City of Santa Barbara California

PLANNING COMMISSION STAFF REPORT

REPORT DATE: March 29, 2007
AGENDA DATE: April 5, 2007
PROJECT ADDRESS: 1114 N. Milpas Street (MST2004-00534)

SITE PLAN
SCALE 1/16" = 1'-0"

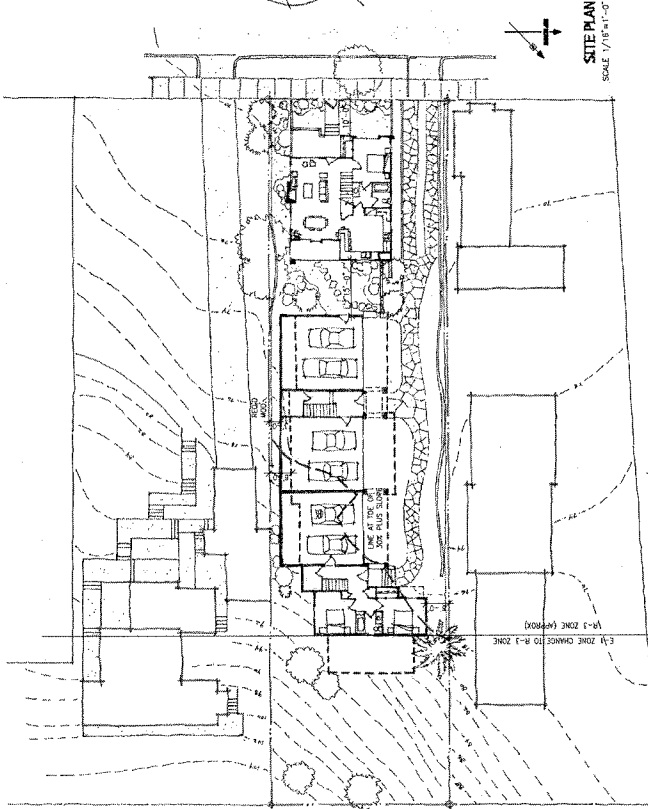
1. Reproduce a completed Project Statistics form, found on the City's website, onto the plans.
2. Although the plans state that the average slope of the parcel is 19.9%, portions of the site where development is proposed may be greater than 30%. Please include a slope study of the parcel that shows, in different colors or shading, areas with existing slopes that are less than 30% and greater than 30%. Consistent with City policy, Staff would not be able to support development on slopes greater than 30%.

3. In the R-3 zone, the rear yard setback is 6 feet for the first floor and 10 feet for each floor above the first. Please revise.
4. On the site plan, through shading or other means, demonstrate how the required 10% common open space area is met onsite.

5. Provide a roof plan for Unit C.
6. Unit C is a three-story building. Please revise the project description.
7. *Noise*: Please revise the Acoustical Analysis report dated December 15, 2006 as follows:
